**DURHAM CATHOLIC
DISTRICT SCHOOL BOARD**
Learning and Living in Faith

**T26-08 Universal Washroom Additions Two (2) Schools - St. James and St. John the
Evangelist Catholic School
Addendum No 2**

Addendum Date: Wednesday, April 22, 2026
Issued by: Purchasing Services
Durham Catholic District School Board

DRAWING No.: **M3.0-A-2** REVISION

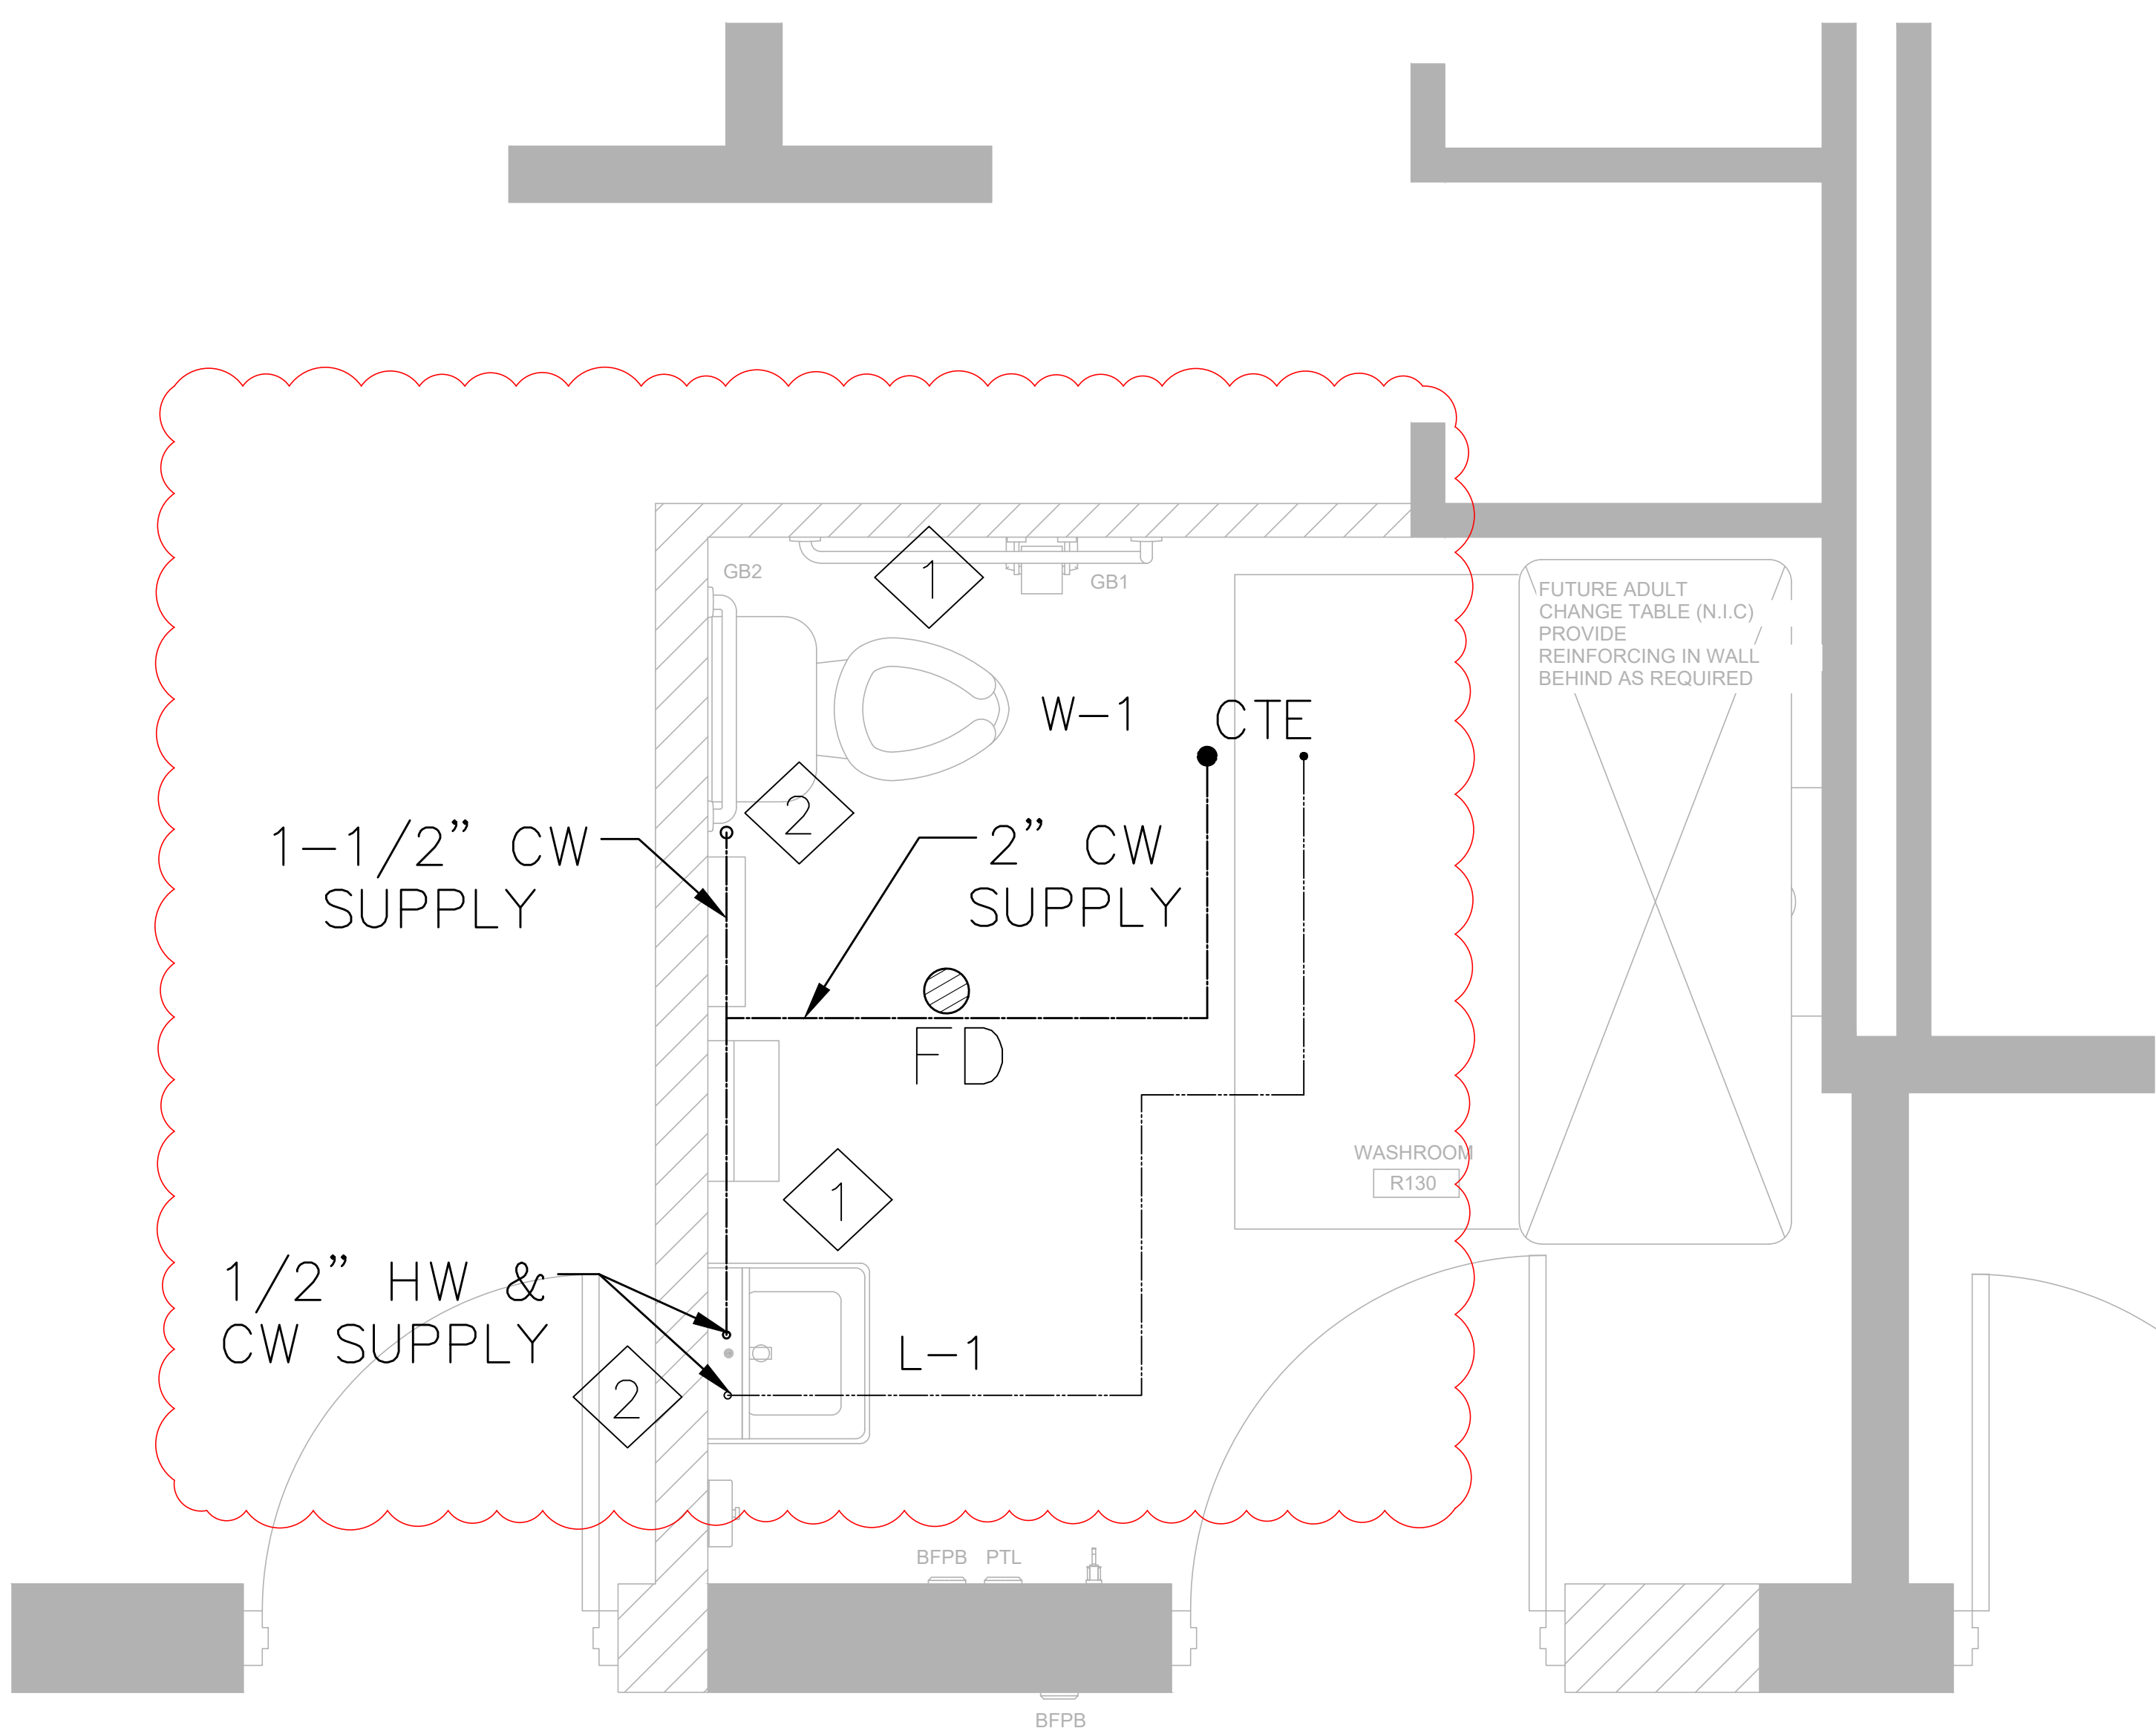
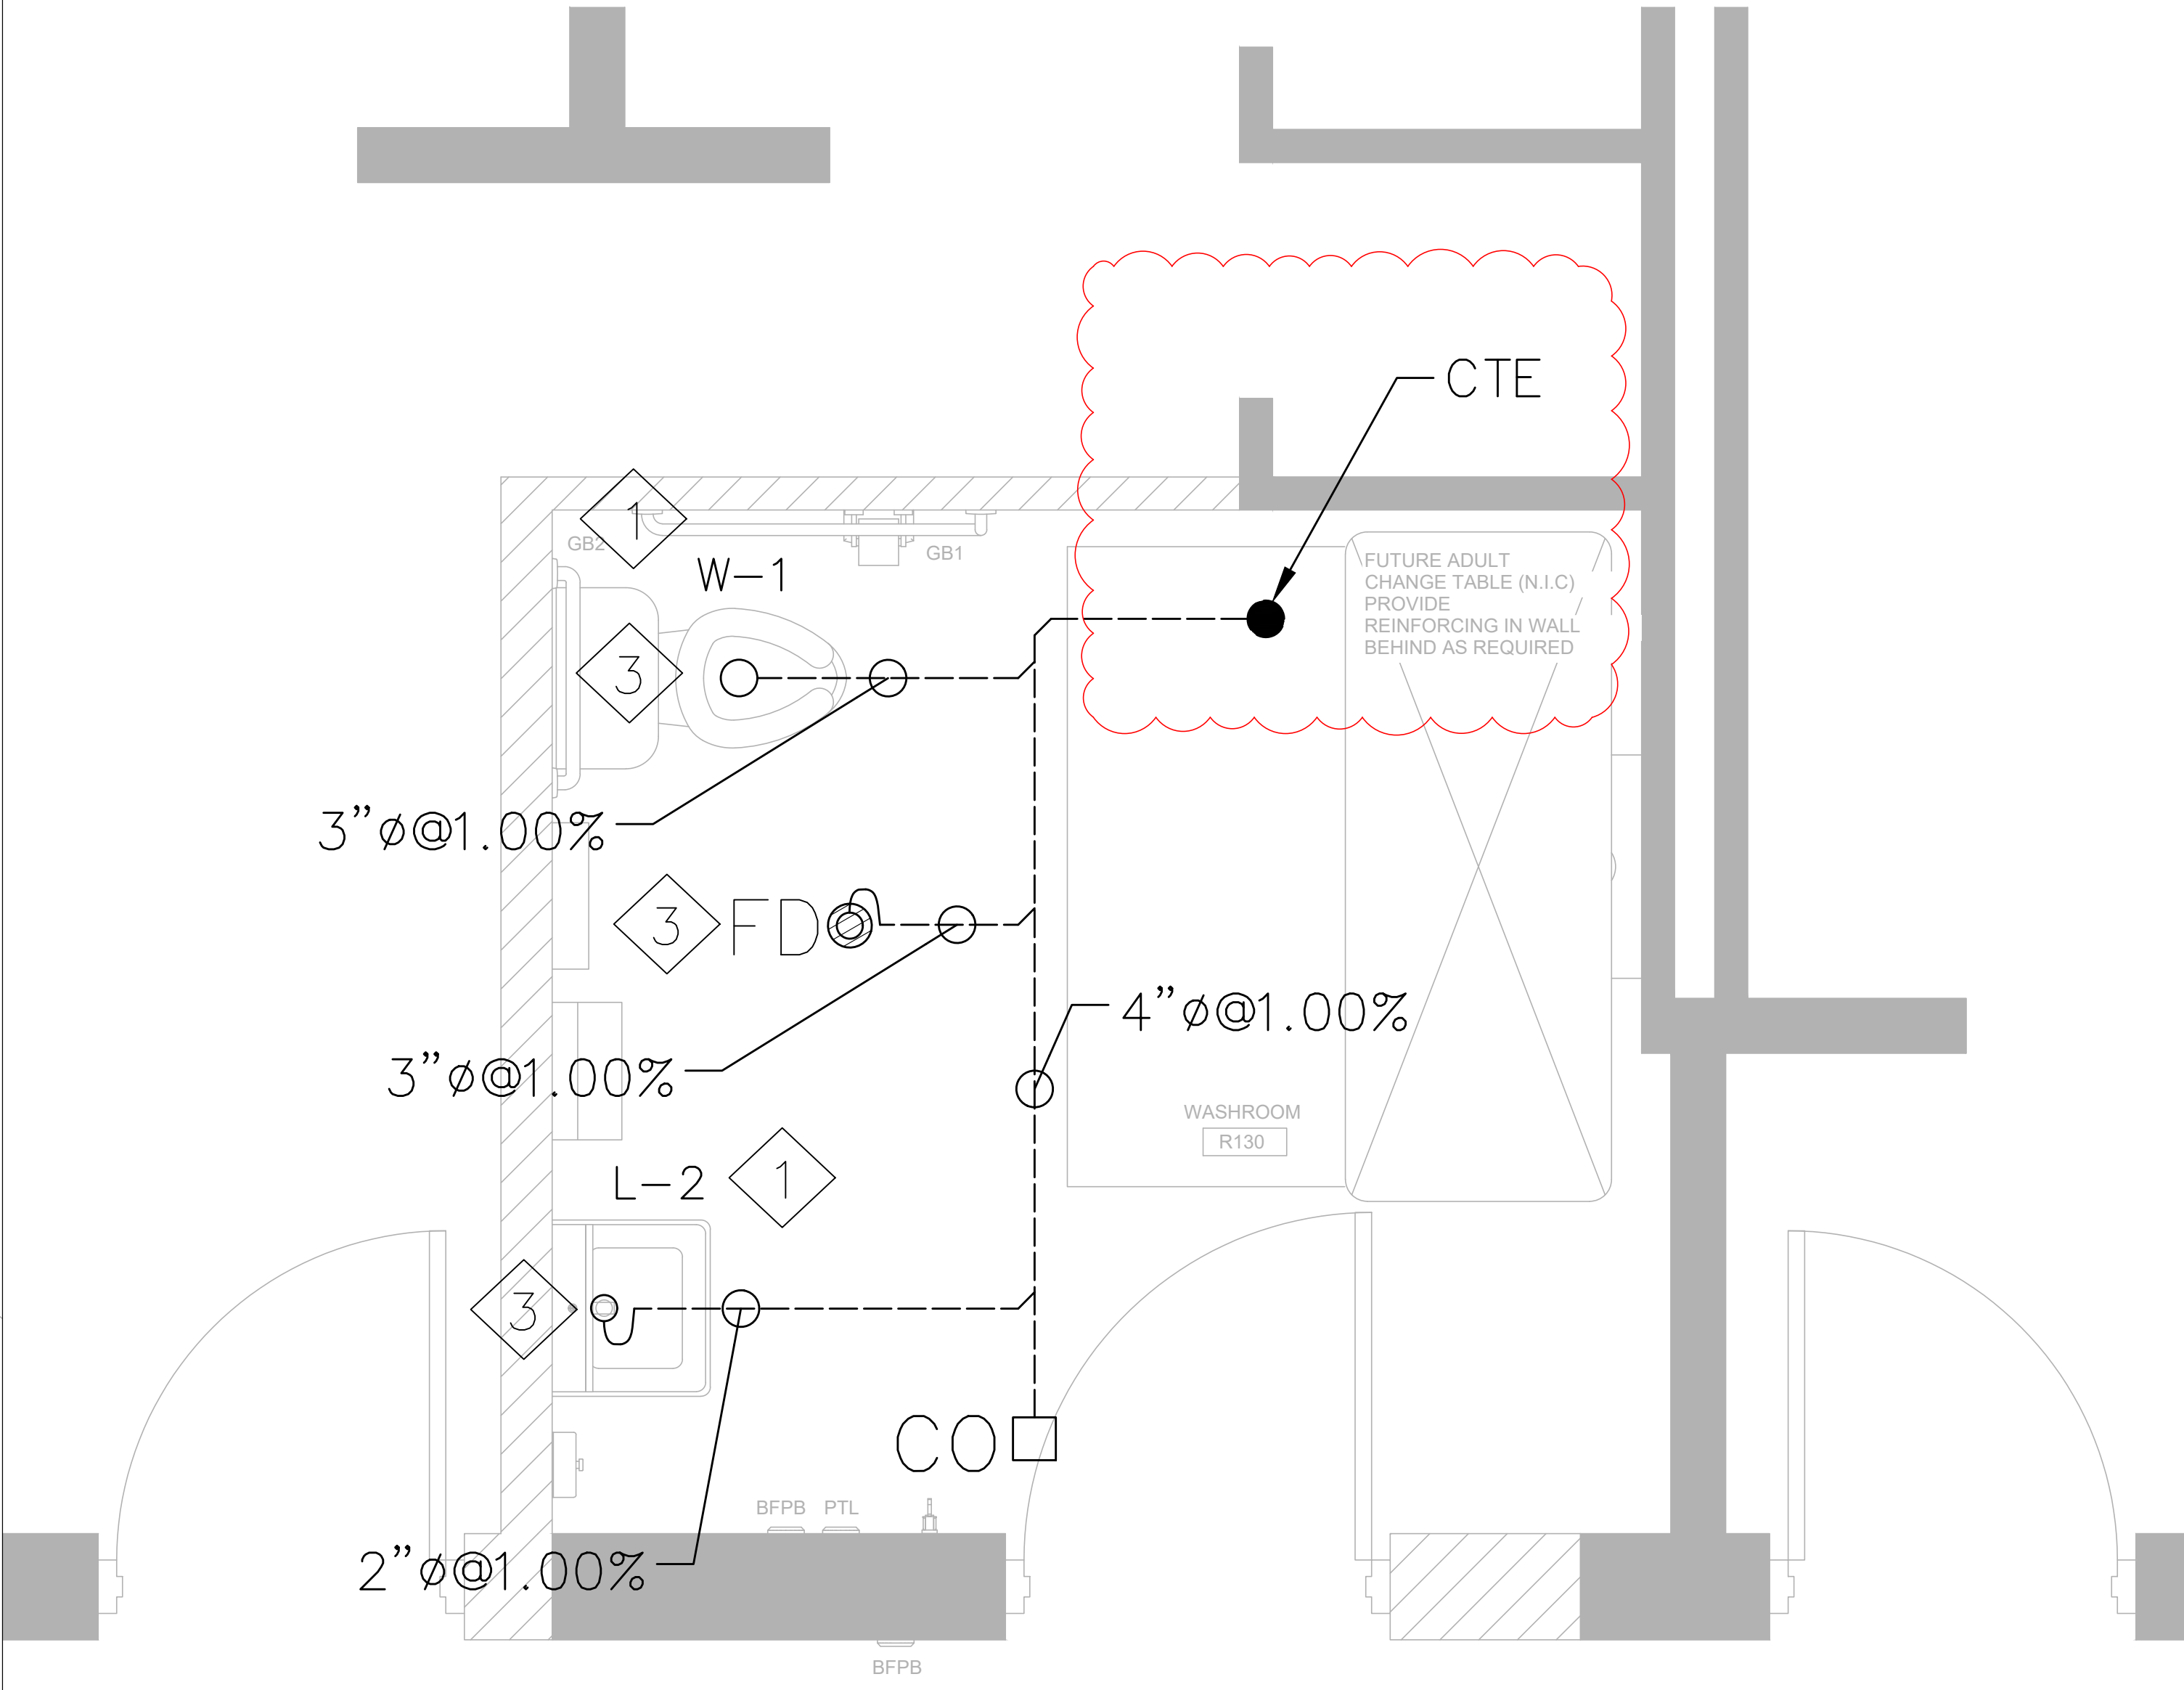
Is the expectation for existing concrete slab but be completely cut and removed within the new washrooms or only as required to complete plumbing scope? Both Locations

Please note that the mechanical contractor must perform a floor scan to find the exact location of the existing underground sanitary lines and is only required to cut and remove the existing concrete slab as necessary to complete the plumbing scope. Refer to mechanical dwgs

- 4** CONTRACTOR TO PROVIDE 3"Ø VENT PIPE RISER TO THE CEILING SPACE AND CONNECT TO THE EXISTING VENTING SYSTEM AS PER OBC AND LOCAL AHJ.
- 5** MECHANICAL TRADE TO SCAN THE FLOOR TO FIND THE EXACT LOCATION OF THE UNDERGROUND EXISTING SANITARY LINE. CONNECT THE NEW SANITARY LINE TO THE EXISTING. THE CONTRACTOR TO CUT AND REMOVE THE CONCRETE SLAB AS REQUIRED TO COMPLETE THE PLUMBING SCOPE.

DRAWING No. : **E2.0 -A-2**

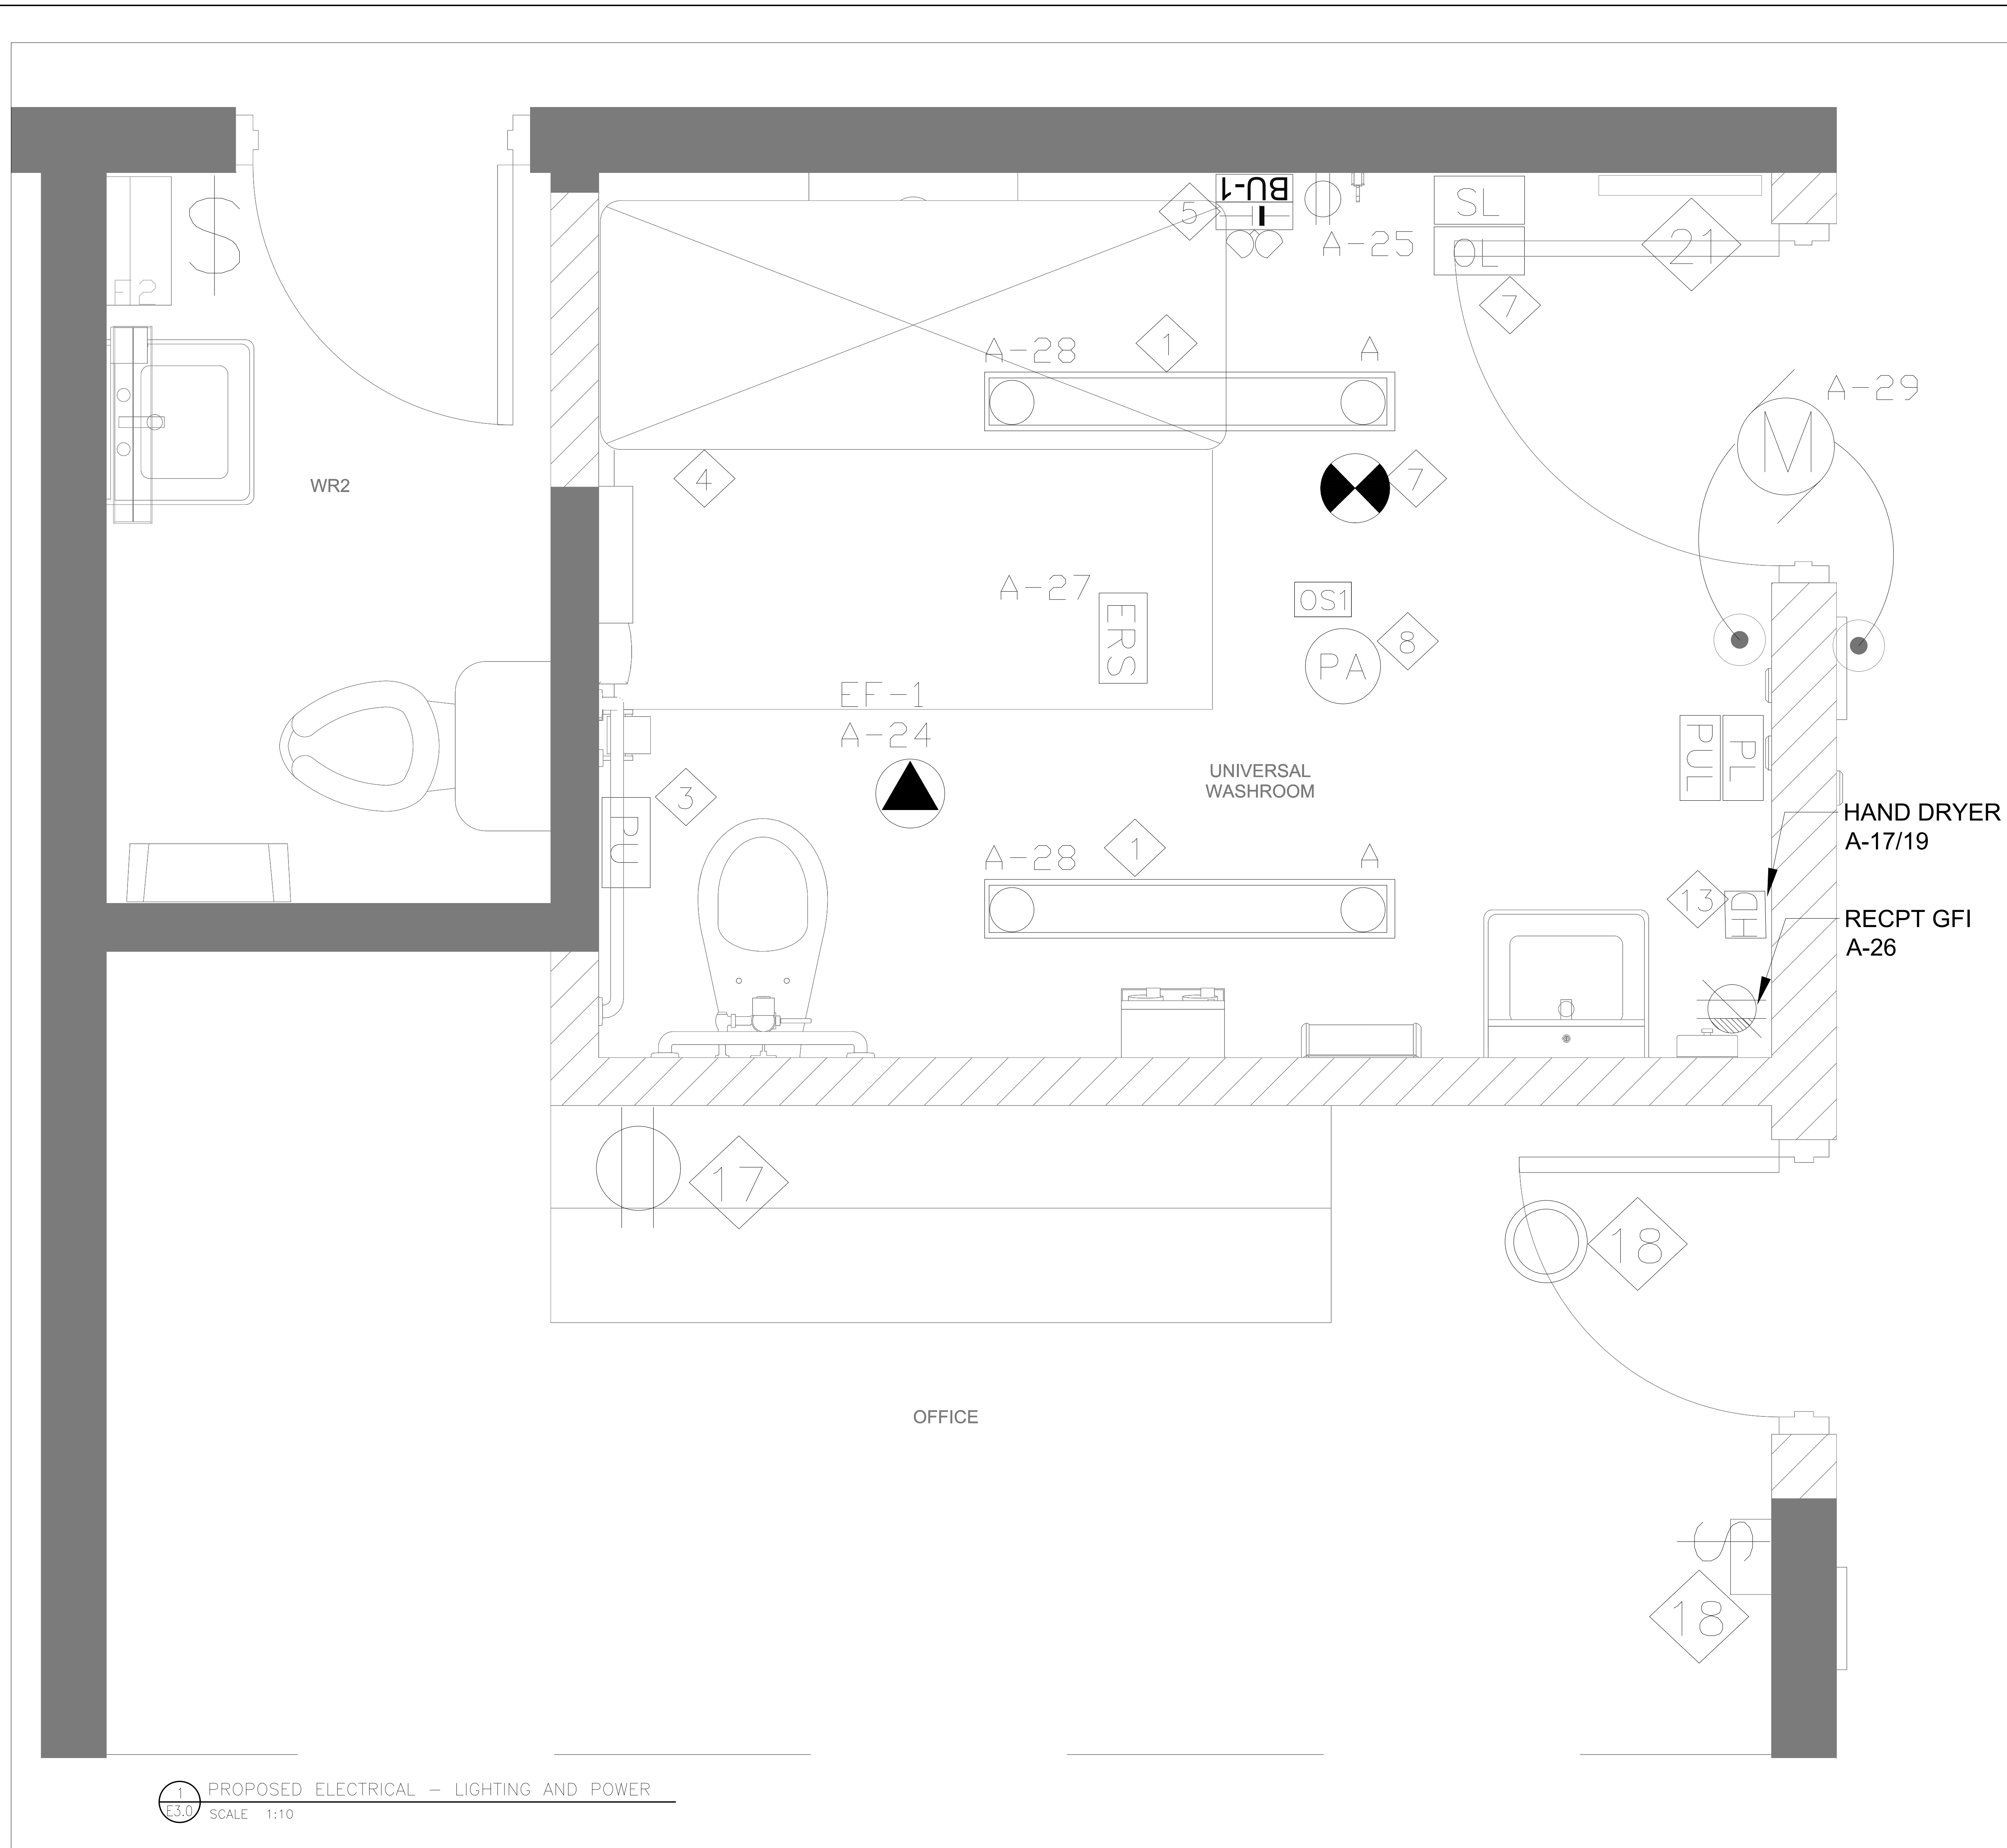
St John - Please confirm scope of demo / mechanical works for existing millwork within adjacent office space.

Remove and re-install the existing millwork on the new wall as required.

7. ELECTRICAL CONTRACTOR SHALL REMOVE ALL THE EXISTING RECEPTACLE AND OTHER ELECTRICAL ITEMS FROM THE MILL WORK, BEFORE DEMOLITION, MAKE CLEAN, BEFORE TO RE-INSTALL.
